L19/D27

THUNDER SCIENTIFIC CORP.

DRAINAGE / GRADING PLAN
THUNDER SCIENTIFIC CORP.

WALL AT SECTION (A)

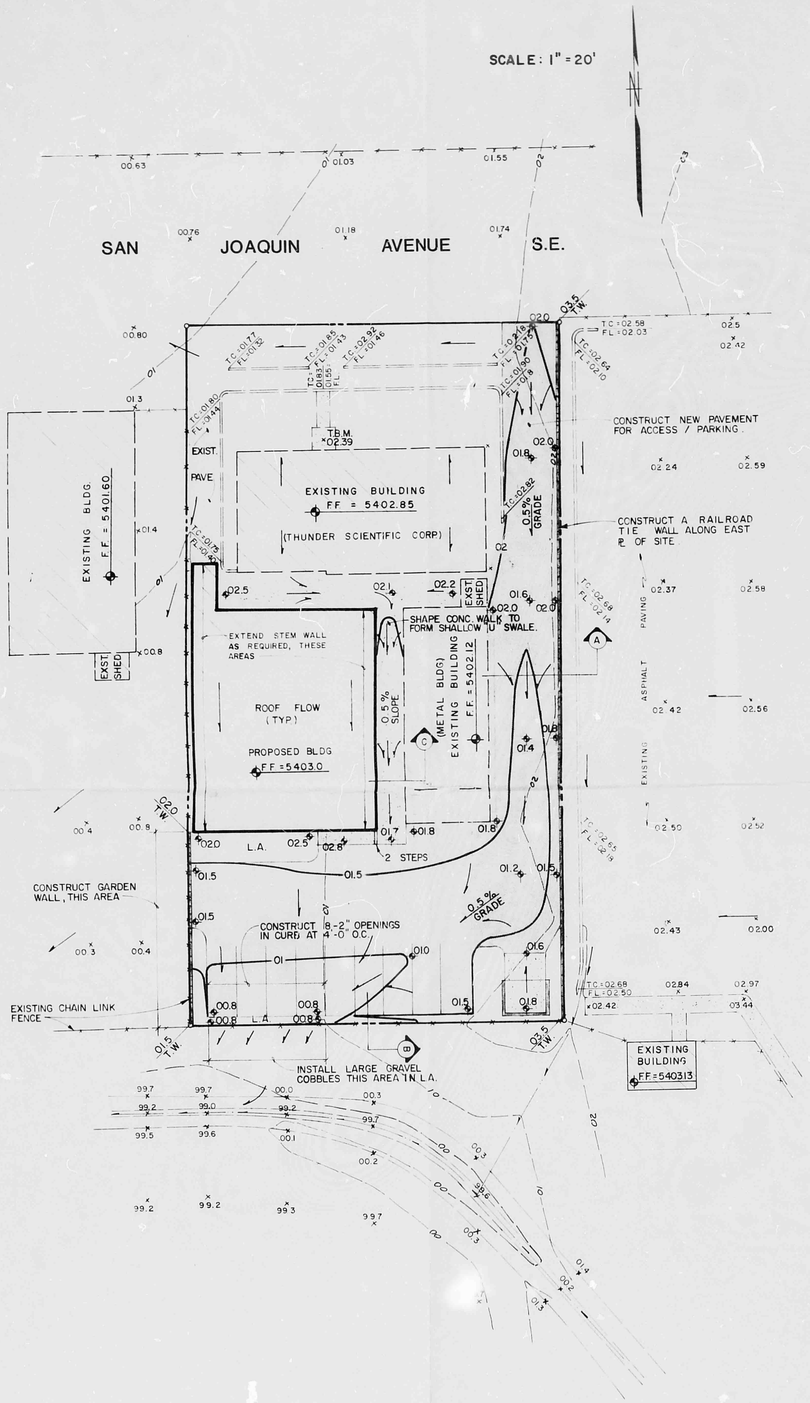
CHANGED 7-9-84
WALL ALONG EAST ℄ CHANGED FROM BLOCK TO R.R. TIES W/ ALUM. FLASHING
